US-APWR DCD Tier 1 Enhancement Project

Thursday 2/17/11 AM Handout 2

Tier 1 Changes Explanation/Basis Document
Tier 1, Section 2.4.1

Figure 2.4.1-3 Reactor Vessel

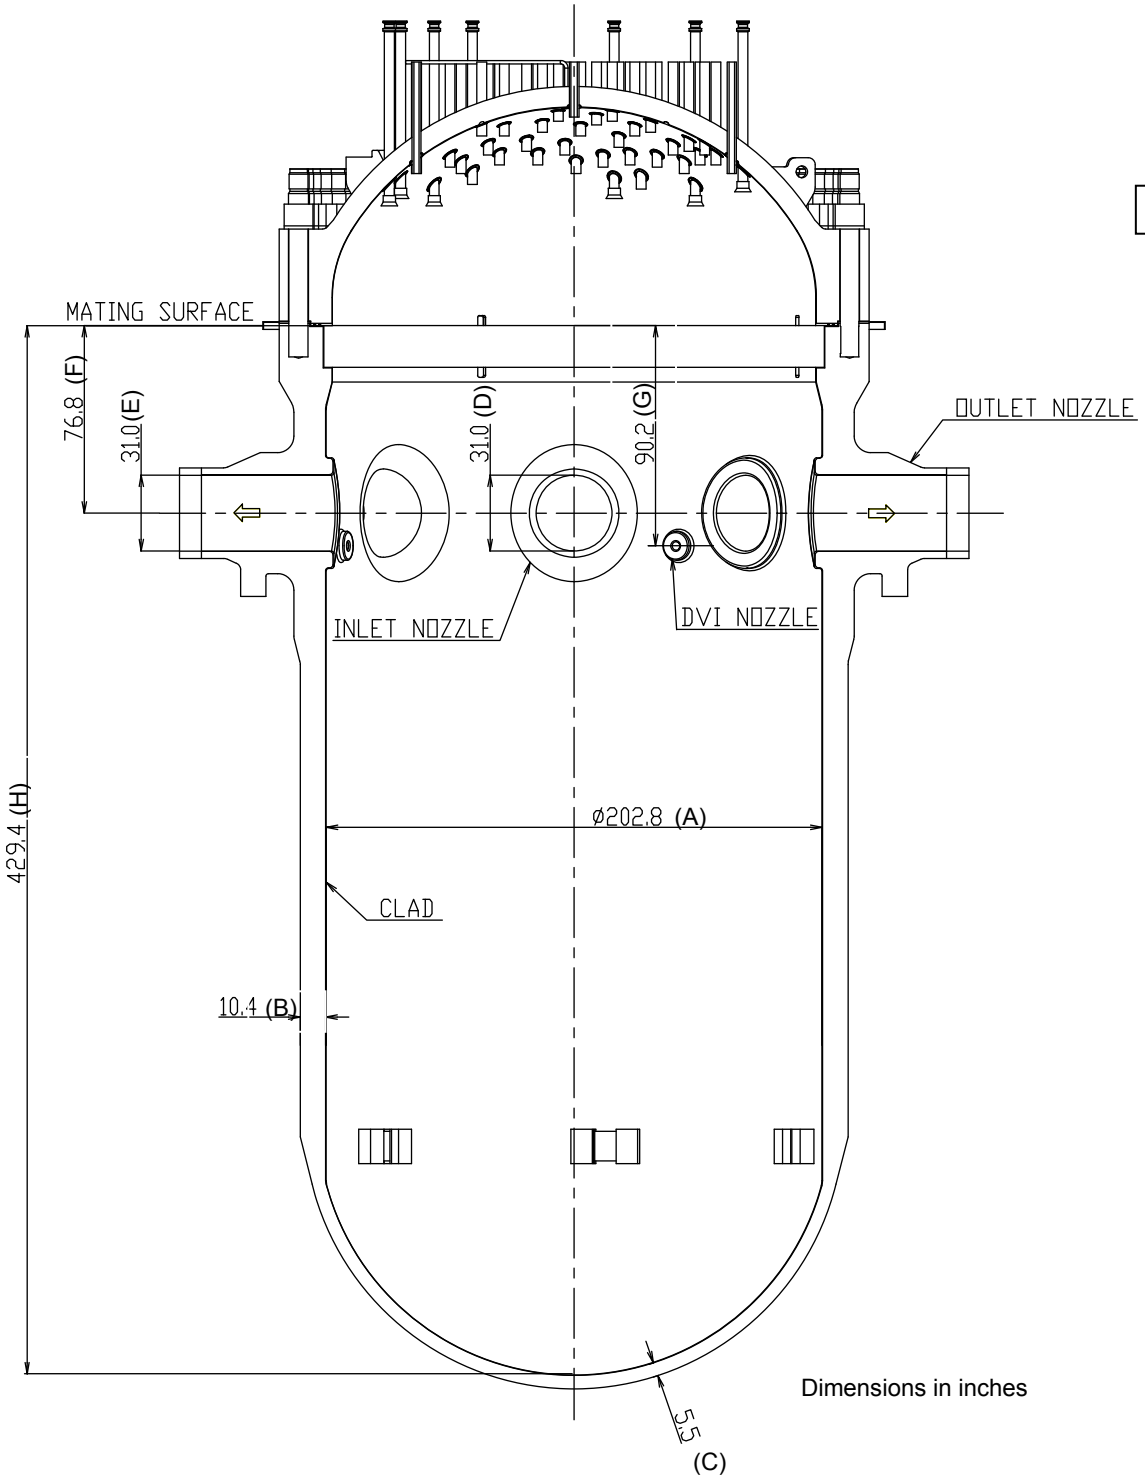
Figure 2.4.1-3	
GG	Addition of the suffix (A thru G) on dimensions of the figure to specify the acceptance criteria in ITAAC #3.

Figure 2.4.2-2 Reactor Coolant System (Sheet 1 of 2)

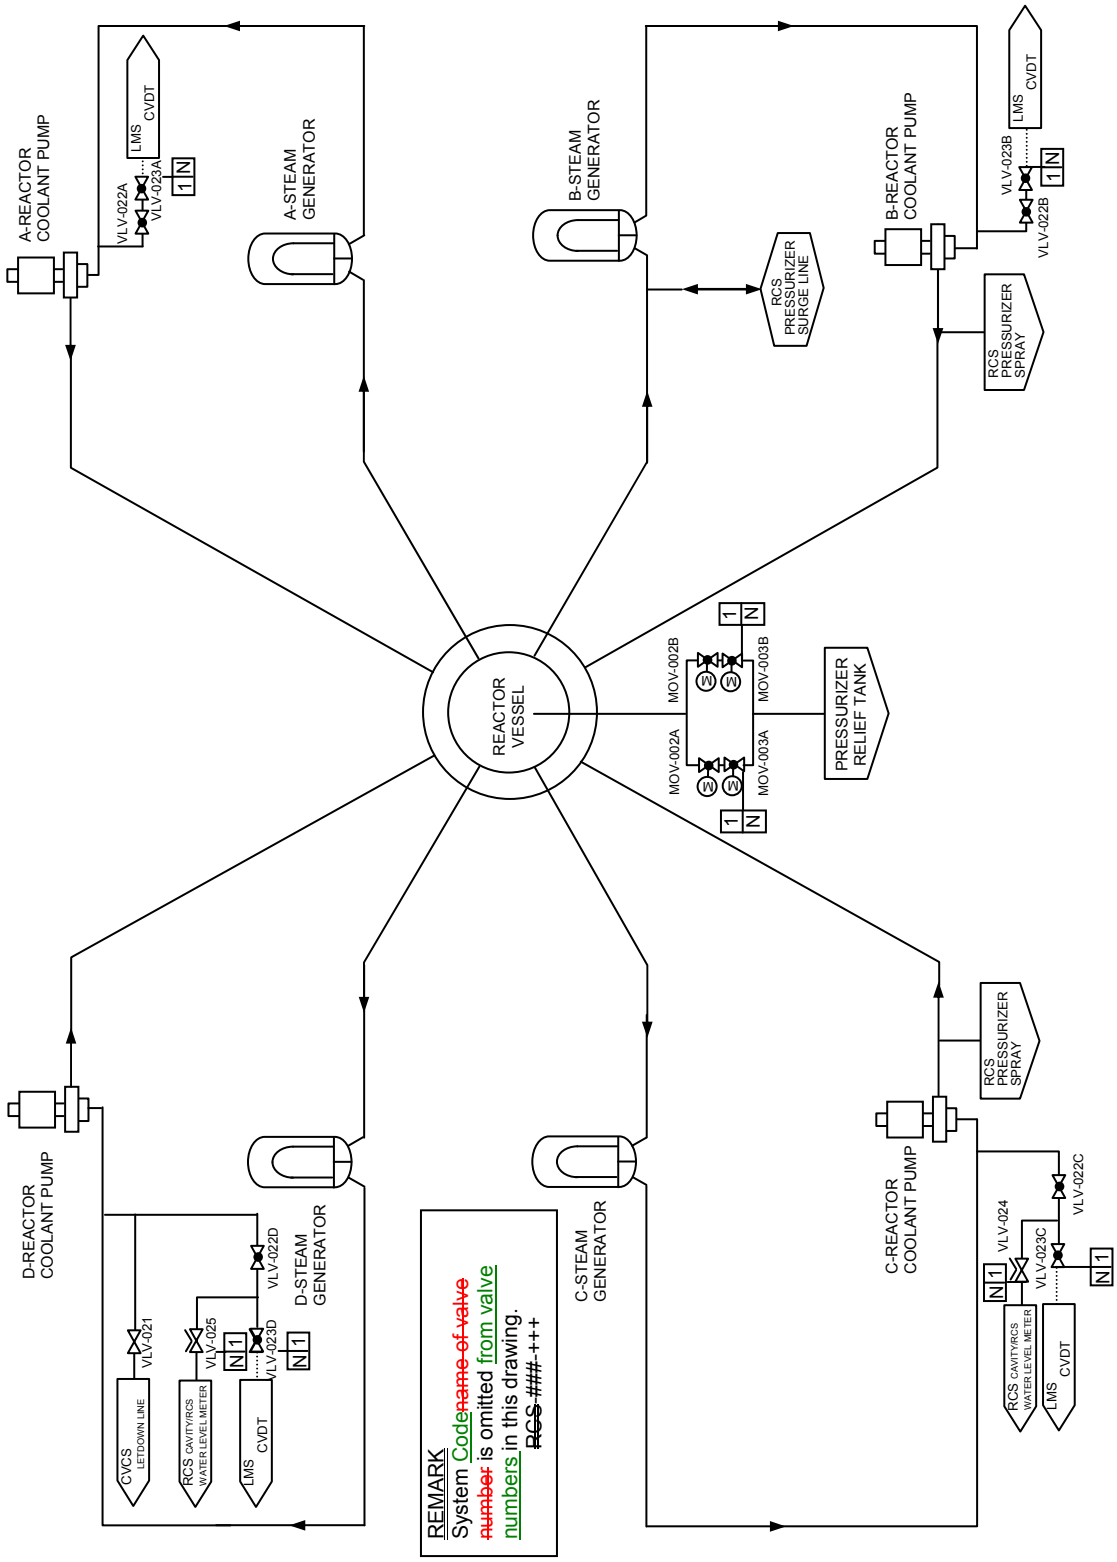
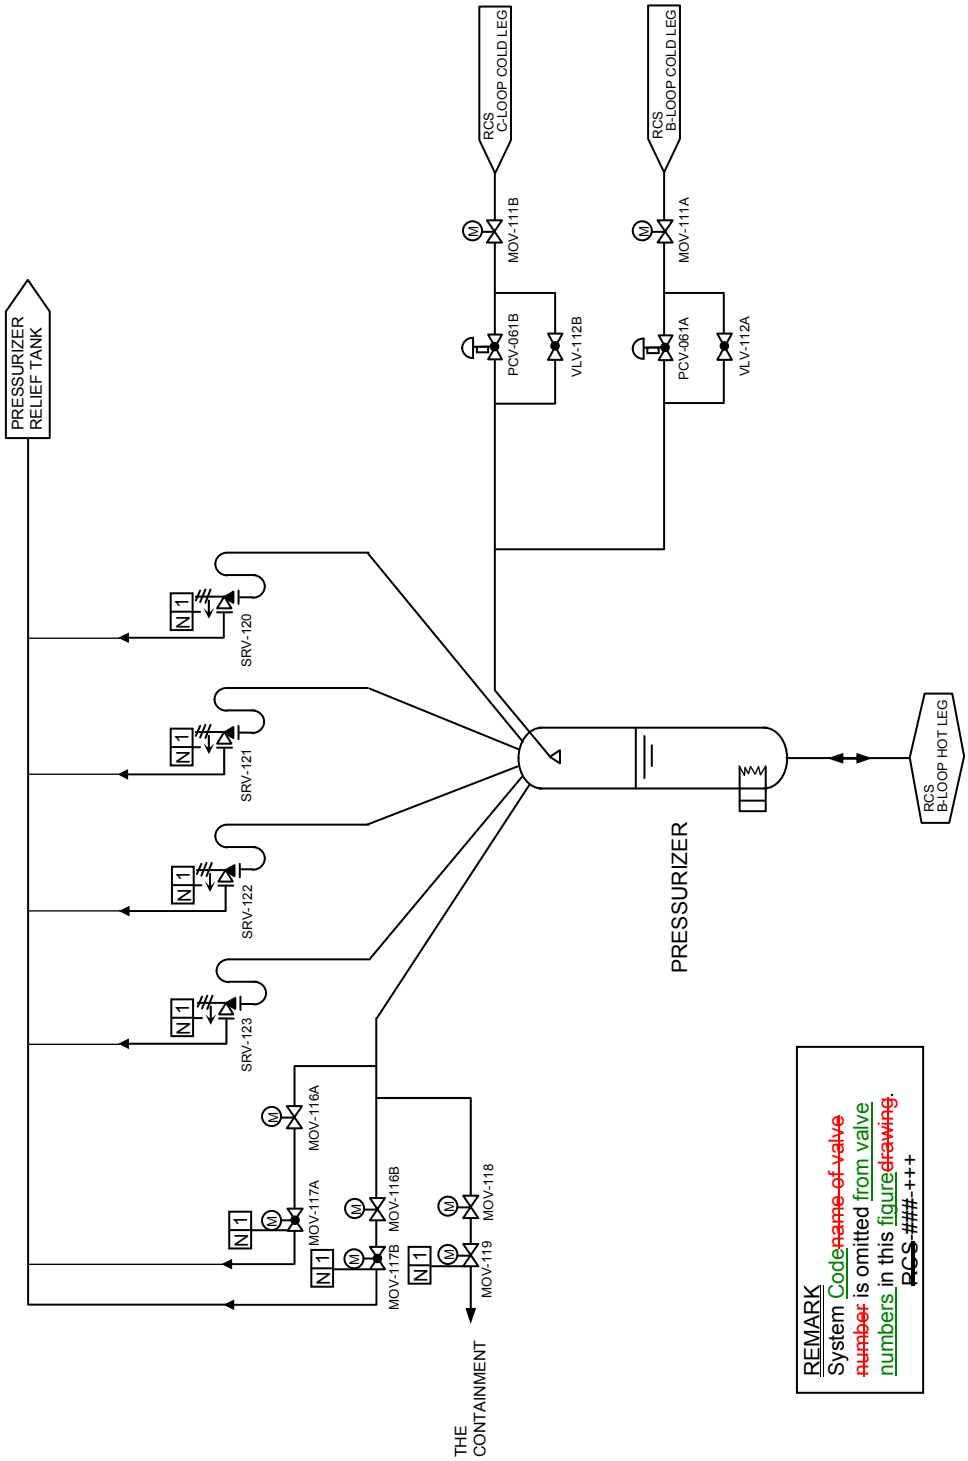
Item No.	Explanation/Basis for Change
No changes	
Figure 2.4.2-2	
Revised "REMARKS" for consistency and clarity.	
Figure 2.4.2-3	
New figure added to provide acceptance criteria for ITAAC item #10.c.

Figure 2.4.4-1 Emergency Core Cooling System (Sheet 1 of 4)

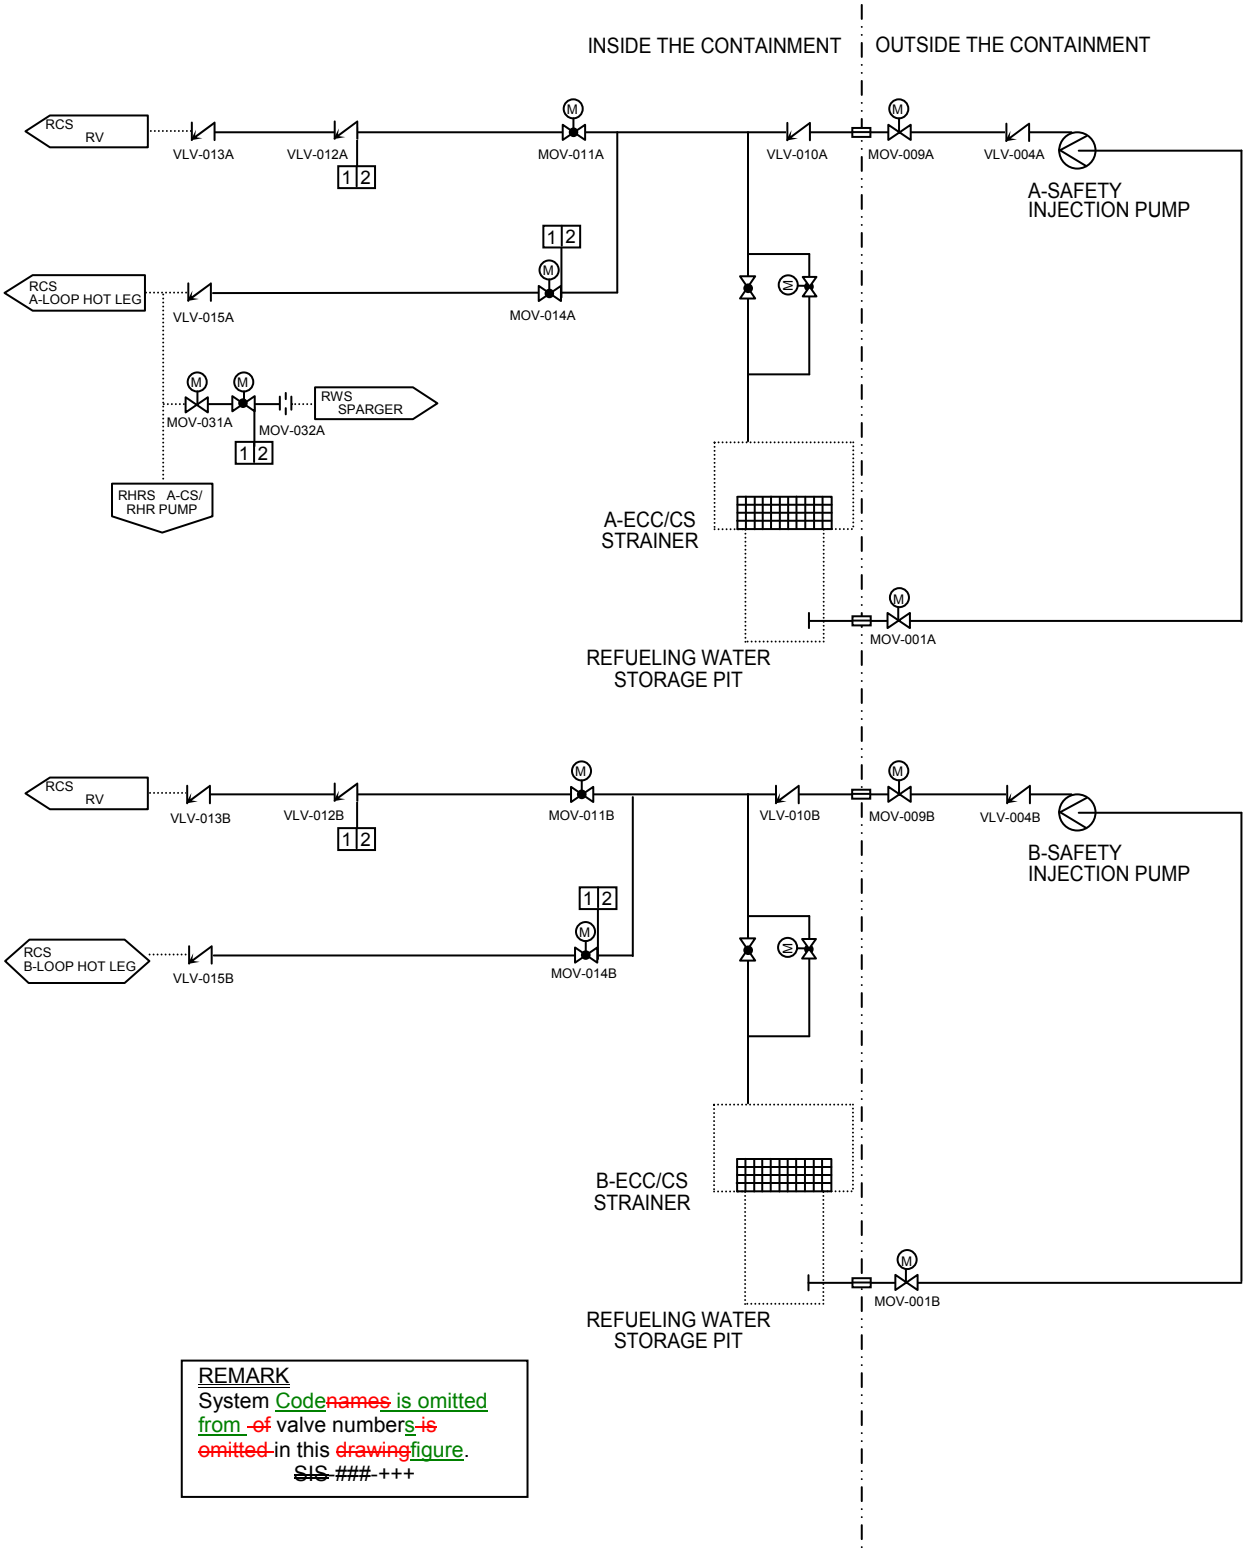
Item No.	Explanation/Basis for Change
14.a	DC, ITA, AC This ITAAC is deleted because this ITAAC is redundant with ITAAC Item 2.a.i.. This change alters the response to RAI 242, 14.03.03-10.
14.b	DC, ITA, AC This ITAAC is deleted because this ITAAC is redundant with ITAAC Item 2.b.i. This change alters the response to RAI 242, 14.03.03-10.
Table 2.4.4-6	
GGG	Correction of typographical error on small flow injection resistance coefficient formula. X should be replaced with Y. Correction of spelling of "uncertainty".
Figure 2.4.4-	
HHH	Revised "REMARKS" for consistency and clarity.

REMARK
System Code~~names~~ is omitted from ~~of~~ valve numbers ~~is omitted~~ in this ~~drawing~~figure.
~~SIS~~ ~~###~~ +++
